# Changes to the Accelerator Design: Status and Outlook

Benno List

ILC@DESY Project Meeting 19.6.2015

**INSERTION OF A DOGLEG IN THE ELECTRON SIDE**

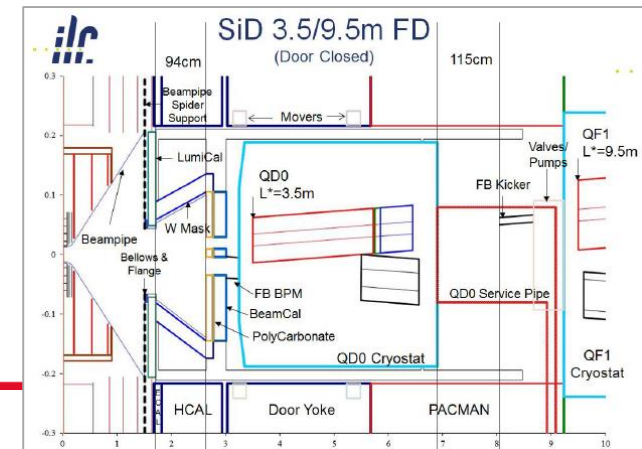
Insert a dogleg of ~400m long between the end of electron linac and the BDS. This should place the BDS on the extension of the electron linac line.

Provide an option for removing the undulator source bypass to support a beamline geometry for possible energy upgrades beyond 500 GeV beam energy, at which energies the existing target bypass dogleg would produce severe horizontal emittance degradation due to synchrotron radiation.

Add an additional estimate 400 m of tunnel to the electron side of the machine. Add an additional 400 m to the positron source and electron RTML lattice. Displaces the existing BDS axis transverse by ~2m.

## CR-0006: BPM downstream of QD0

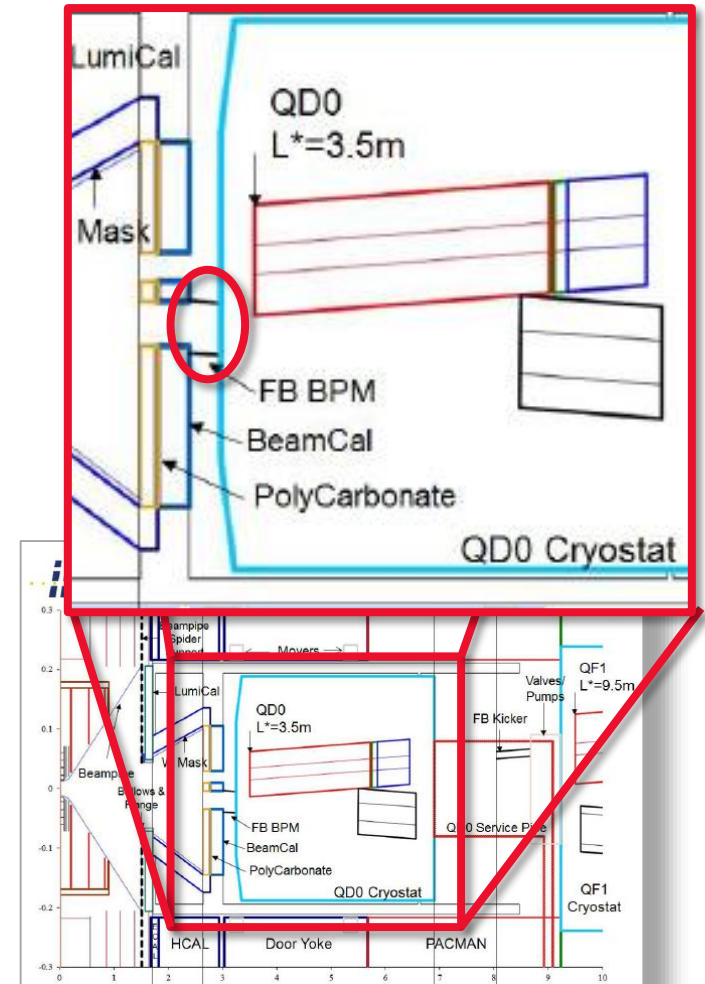
- Corollary of CR-0002:  
Once ILD redesigns its entire forward region, might as well make room for a 10cm Beam Position Monitor
- Our “smallest” CR so far
- CR document is just 2 pages
- Was submitted in 6<sup>th</sup> CMB meeting and accepted in 7<sup>th</sup> meeting
- Implementation will be lumped together with CR-0002
- application of “lightweight” decision procedure for simple CRs
- We do not want to create more bureaucracy than necessary

Hybrid-A' General layout

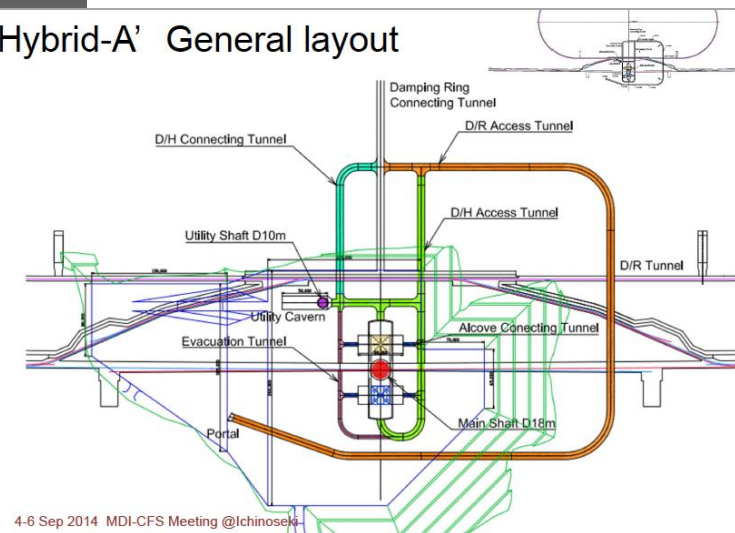
- Change Request with the longest preparation time so far: ~1 year
- Discussion started in CFS&MDI session at LCWS13 (Nov 13) after Japanese recommendation of Kitakami site:  
Kitakami has hills, not mountains -> vertical shaft might be possible
- Very thorough preparation with lots of studies by CFS and MDI group before submission of the Change Request in Oct. 14  
by a joint group of CFS, MDI groups and both detectors  
-> most of the work was already done

## CR-0003: Status now

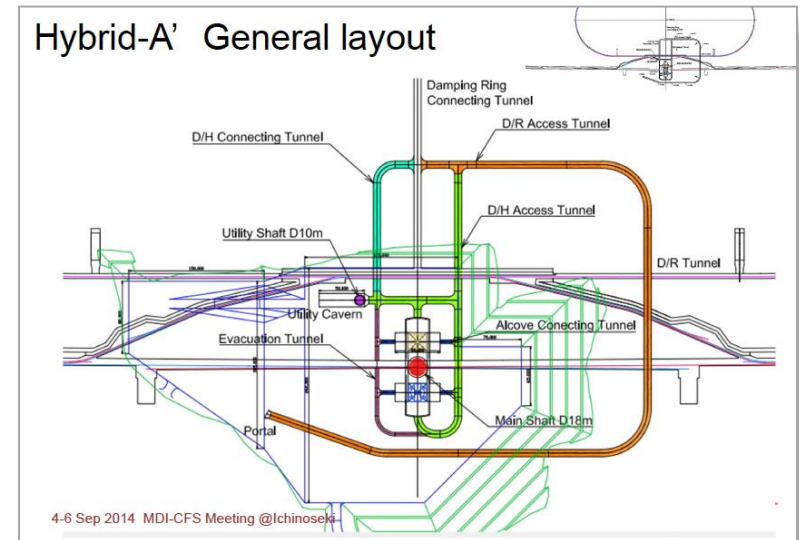
- CR-0003 submitted at 2<sup>nd</sup> CMB meeting 9.10.14
  - Approved at 3<sup>rd</sup> CMB meeting 20.11.14
  - Change Implementation Team (CIT) formed at 4<sup>th</sup> CMB meeting
  - Implementation is close to complete, final implementation document is being prepared
- 
- A very complex Change Request:
    - Interaction point had to move by ~800m
    - Needs new/more Geologic study
    - Completely new Experimental hall design
    - Completely different way to build / assemble / install detectors
  - A large and important decision to take
  - Needed all stakeholders (detectors, CFS, site experts) on board

## CR-0004: Extension of the Main Linac tunnels

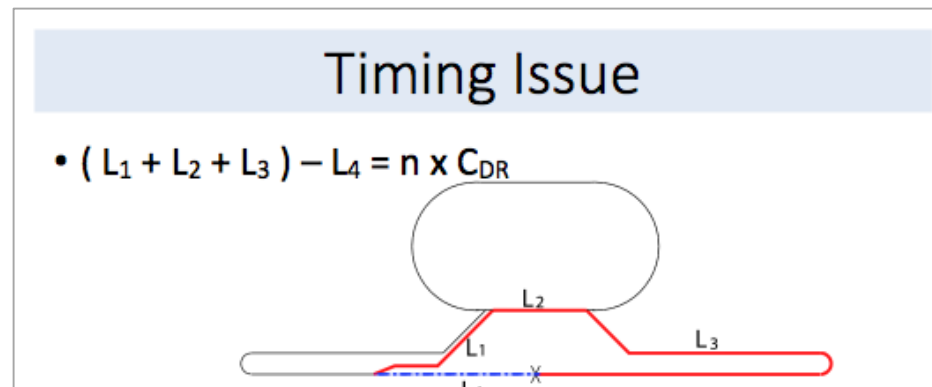
- Another CR with a long history
- Undulator positron source constrains round-trip length around accelerator to be an integer multiple of the Damping Ring circumference
- TDR layout is 150m too long, or 1500m too short, for current DR
- There are several ways out, but:  
1.5 km more Main Linac tunnel would make it easier to react **\_if\_** cavity gradient of 31.5MV/m would be below design value of 31.5 MV/m, and one still wants to reach 500GeV
- This “reaction” would still require building more cavities, cryomodules, klystrons etc -> would be costly, but possible
- Why is 500GeV important?  
Before Higgs discovery, 500 was an arbitrary, round number.  
Now, 500 GeV is just high enough above the tth threshold!
